223 West Newton St.
Head House Re-Siding

Amended Submission – October 26, 2022

Information Requested by South End Landmark District Commission

PROPOSED TILE PLACEMENT PENTHOUSE FRONT WALL

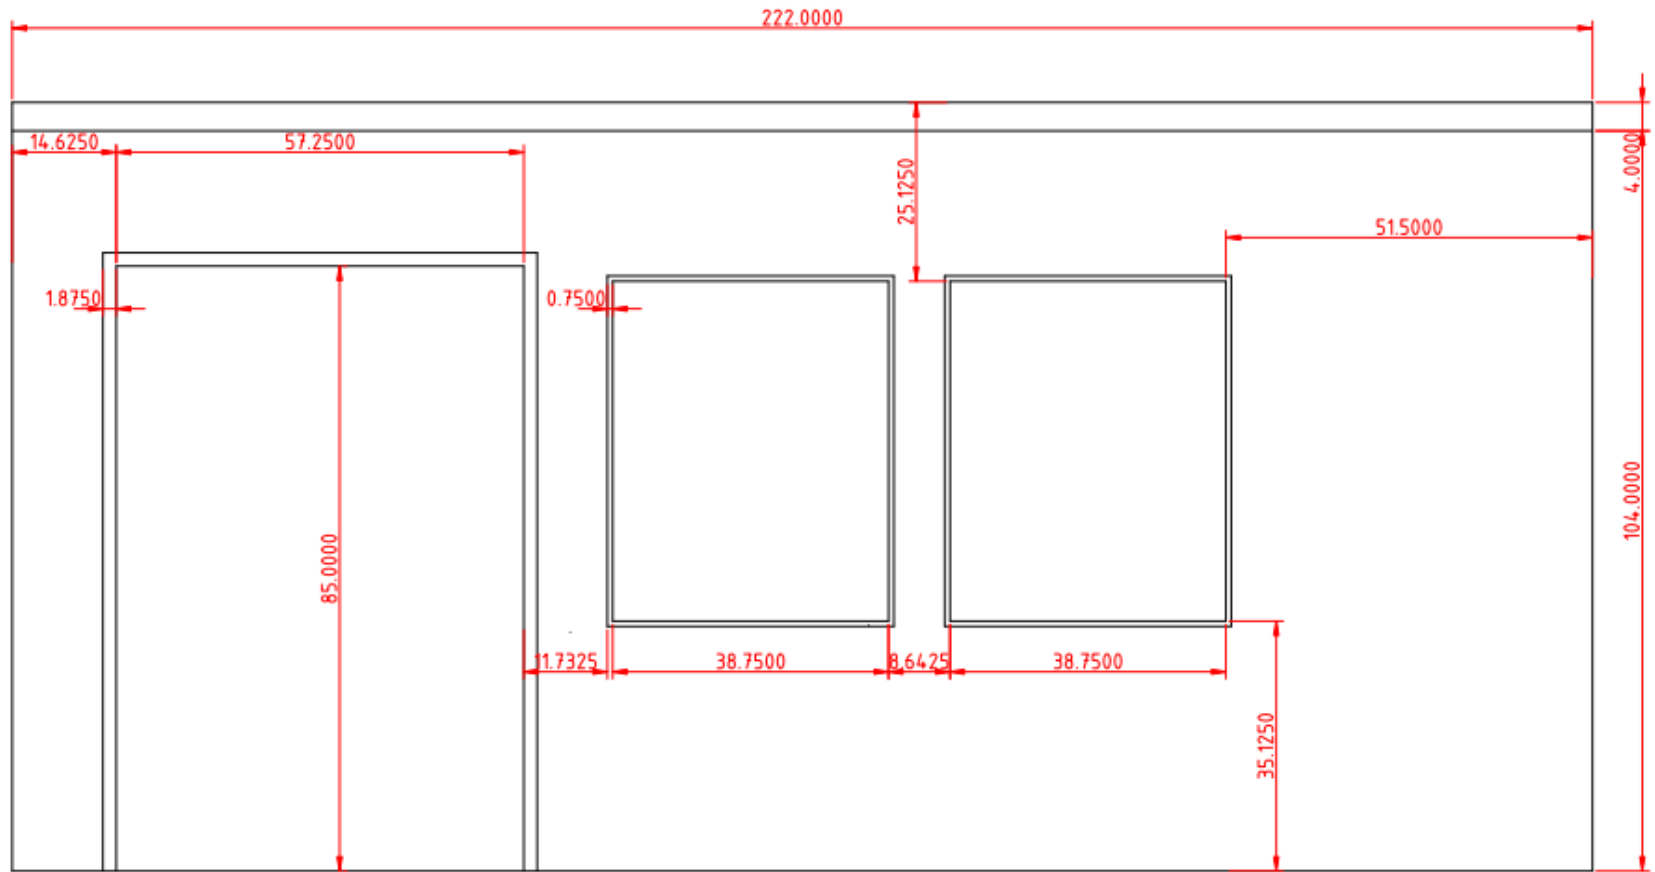
- **Cutting Tiles to Size:**
 - Contractor does not have concerns about sizing the tiles to fit in between the windows. They come in a variety of sizes and can be cut cleanly as needed.

- Footprint of where the tiles will be placed vs. brick will be the same as current material.
 - See Image 1 on [slide 8 \(Additional Images of Slate Shingles\)](#) for example of custom sizing.

Additional Images of Slate Shingles

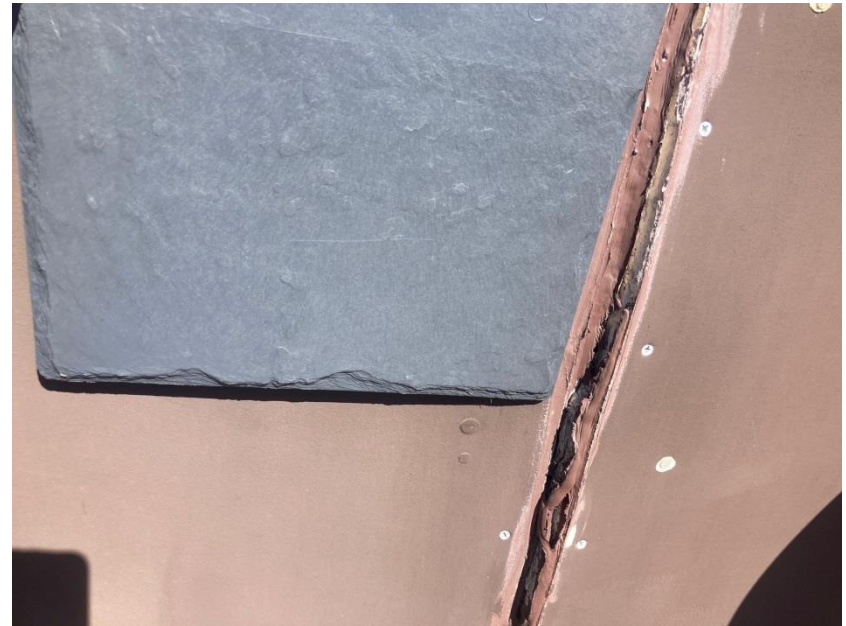
- See Image 2 on [slide 8 \(Additional Images of Slate Shingles\)](#) for example of step flashing.
- **Window Molding:**
 - There will be no change to molding. Windows will remain the same dark gray color and the frames are only $\frac{3}{4}$ inch wide.

- EcoStar shingles installed by our contractor, Secure Roofing, on near-vertical surface in same pattern as traditional slate
- Step flashing can be sourced in copper, gray, or other preferred colors
